# Rezoning Transportation Analysis

Petition Number: 2019-034

## Revision Log:

Date	Description
04-16-19	First Review
05-20-19	Second Review

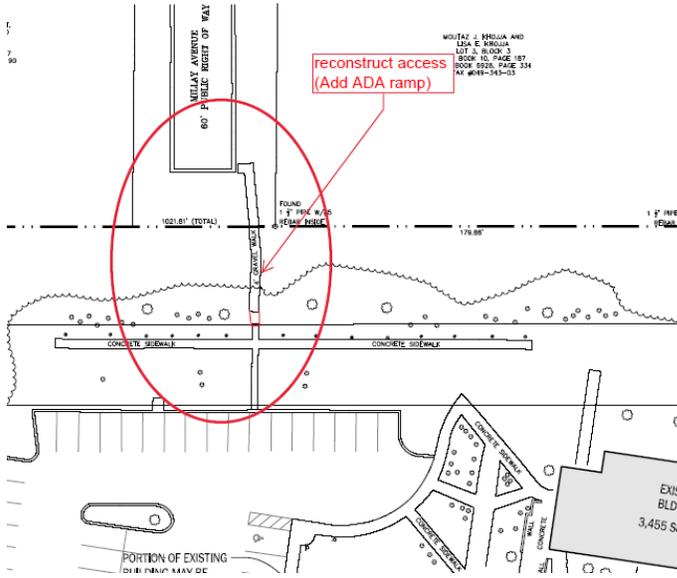
- ~~1. **Traffic Study** A Traffic Impact Study is not necessary for the complete review of this petition.~~
- ~~2. The site plan notes and the building square footage notes do not match. The petitioner should rectify the difference in order to determine the actual proposed square footage for the site.~~

- ~~The petitioner should revise the site plan and conditional note(s) to commit to formalizing the pedestrian access at Millay Avenue and create an ADA ramp for the pedestrian access leading to "Millay Avenue". This pedestrian accommodation would be beneficial for the adjacent neighborhood to update access so that the gravel walk is upgraded to an ADA compliant surface such as concrete or asphalt and connecting what appears to be a gap between the gravel walk and the concrete sidewalk. The site plan should include notes to commit to the connection. **Comment rescinded**~~

- ~~The petitioner should revise the site plan and conditional note(s) to commit to reconstruct driveway access that will primarily be used by the class portion of the site to a Type II Modified driveway. The site plan should include notes to commit to driveway construction. **Comment rescinded**~~

- ~~The petitioner should revise the site plan to add a note specifying dedication and fee simple conveyance of all rights of way to the City before the site's first building certificate of occupancy is issued. CDOT requests right of way set at 2' behind back of sidewalk where feasible. **Technical Correction:** Petitioner should update site plan to show R/W dimension from road center line and to show 2' easement from back of sidewalk.~~

- ~~The petitioner should revise the site plan to add a note specifying all transportation improvements will be approved and constructed before the site's first building certificate of occupancy is issued. The petitioner may phase transportation improvements if said improvements and phasing are explicitly described in site plan notes.~~
